# 825 North Roxbury Drive

**STAFF REPORT**  
**CITY OF BEVERLY HILLS**

For the Design Review  
Commission Meeting of  
January 7, 2009  
PL0932655

**SUBJECT:** A request for an R-1 Design Review Permit to allow a façade remodel and new landscaping for an existing two-story single-family residence, located in the Central Area of the City, north of Santa Monica Boulevard at 825 North Roxbury Drive.

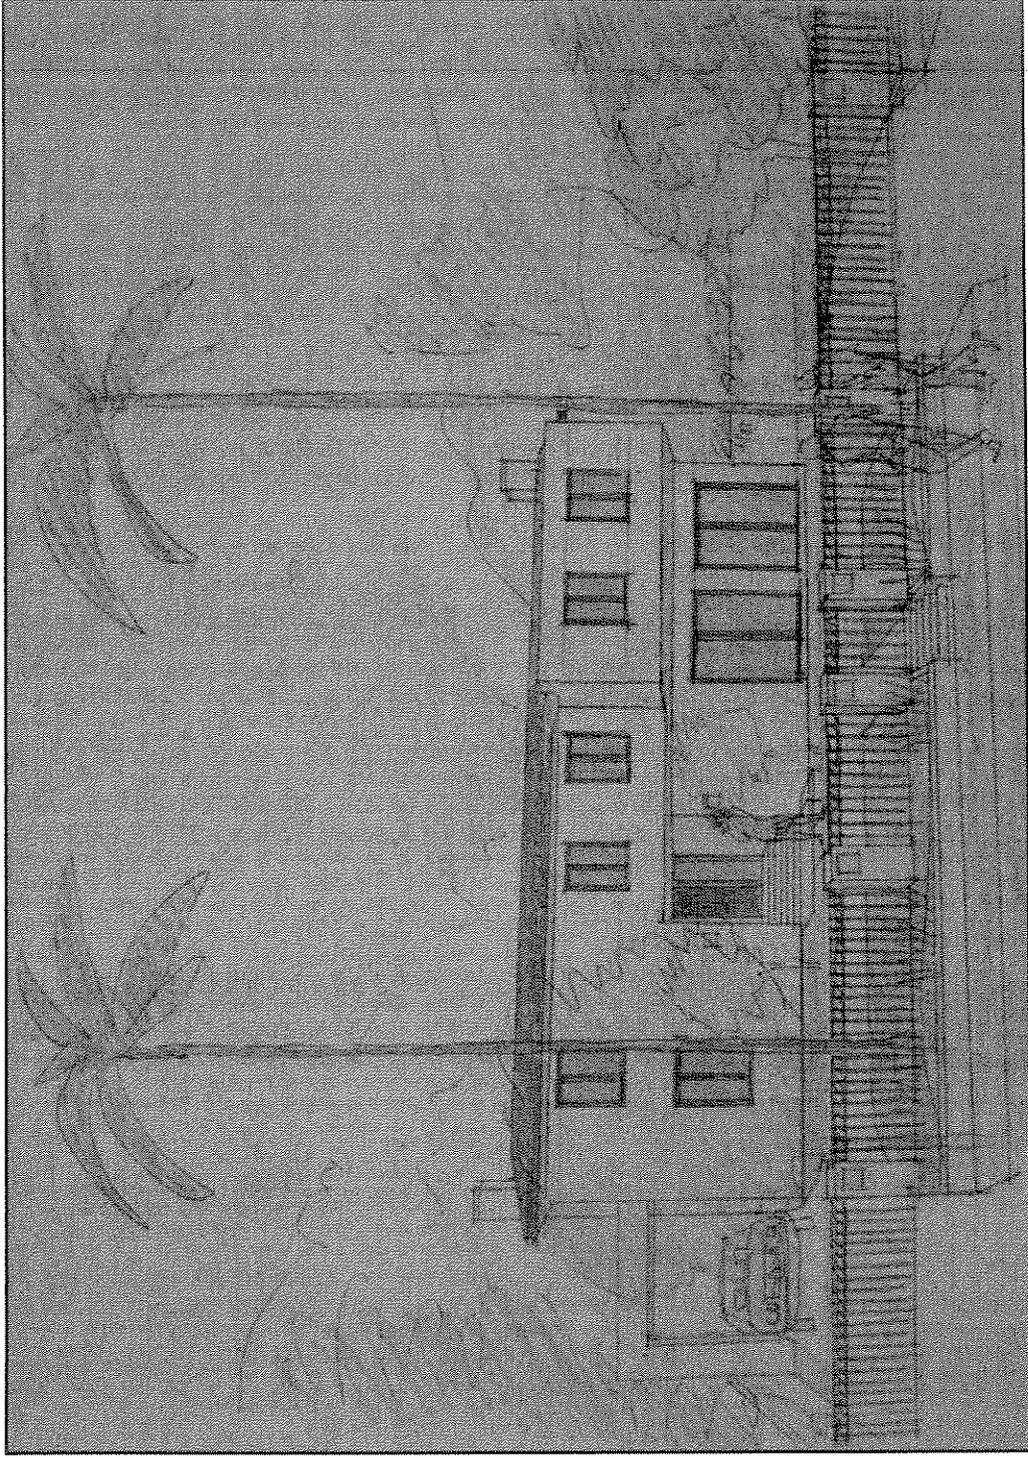
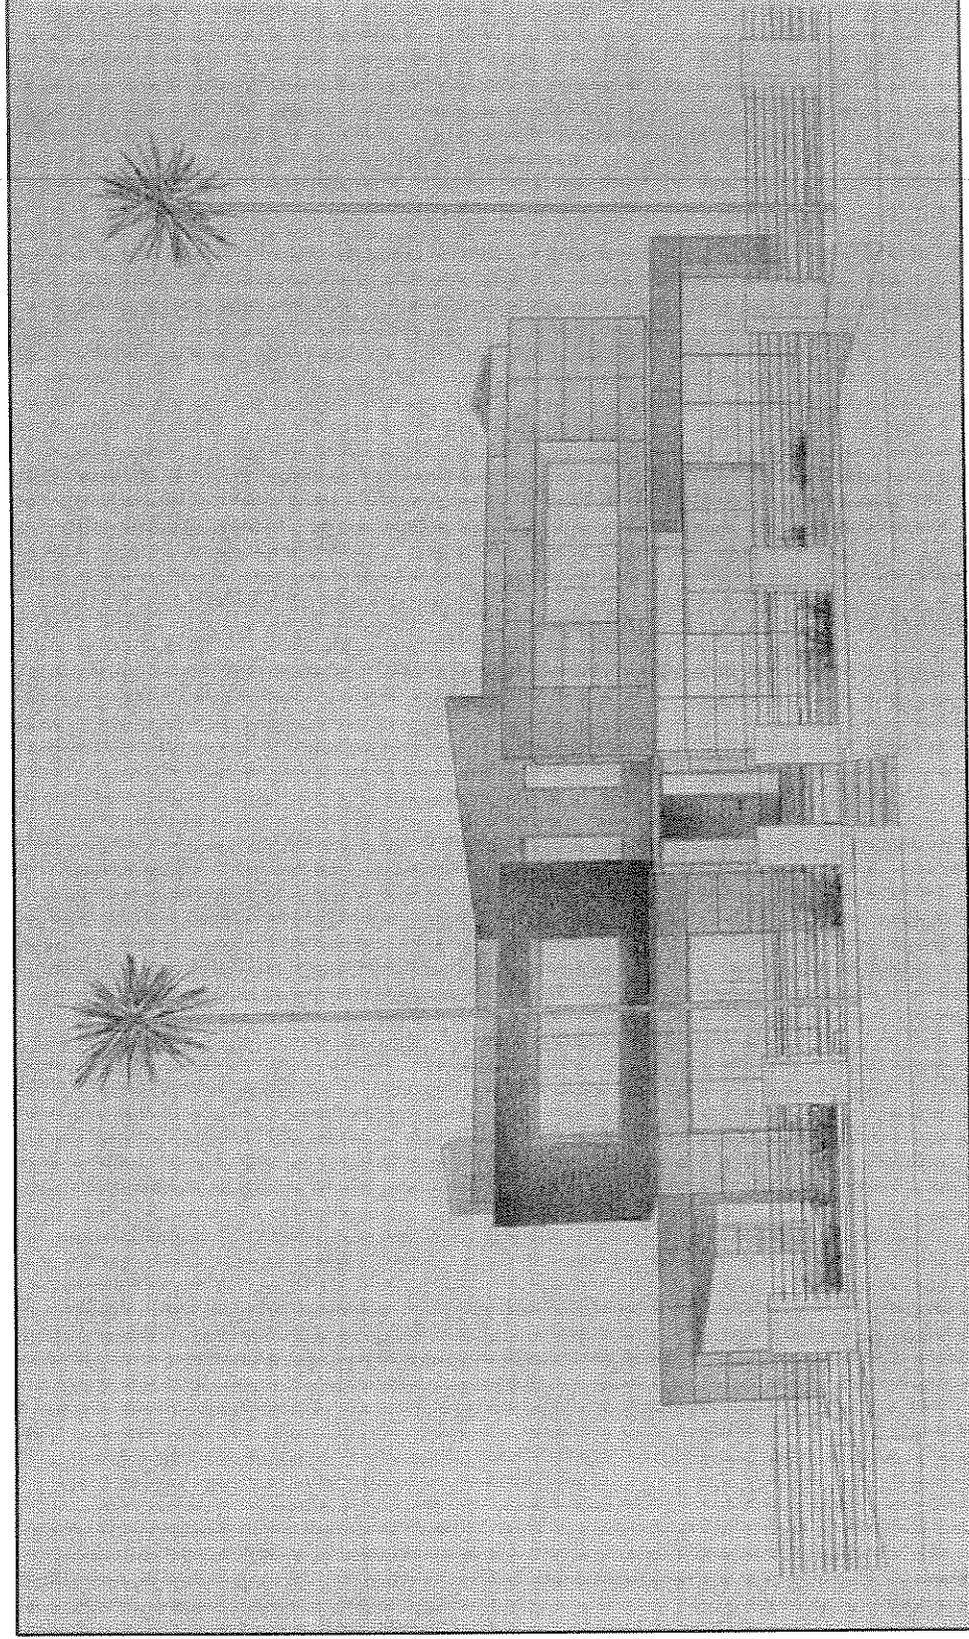
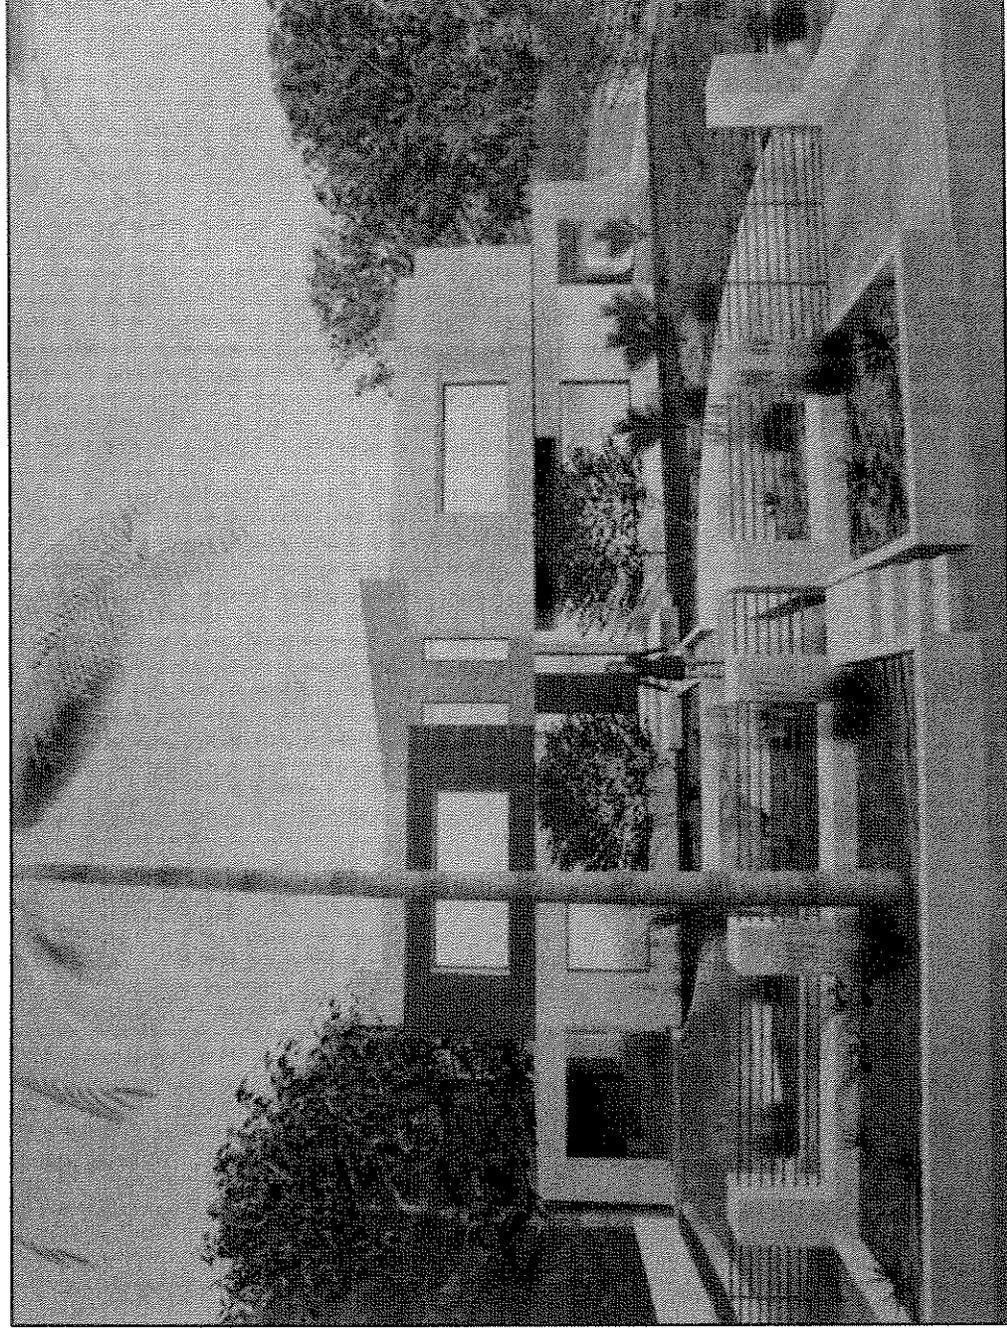
Commission Comment	Proposed Modification
1. The landscape plan should be revised to address privacy issues along the southern property line.	1. The applicant has revised the landscape plan to include three 15-gallon fern pines in between the primary residence and the pool house, along the southern property line.
2. A survey of the property should be provided as a component of the final plans.	2. The applicant has provided a survey for review by the City.
3. The perimeter fence within the front setback should be redesigned to	3. The applicant has provided a revised fence design for the Commission's

appear more residential and less commercial.	review.
4. The proposed vinyl windows should be changed to anodized aluminum.	4. A condition has been added to the draft Resolution requiring anodized aluminum windows, rather than the previously proposed vinyl windows.

1. All windows visible from a public right-of-way shall have anodized aluminum frames, rather than the previously proposed vinyl frames.
2. All landscaping shall conform to the approved landscaping plan insofar as species, quantity, location within the subject property, and size at the time of planting.
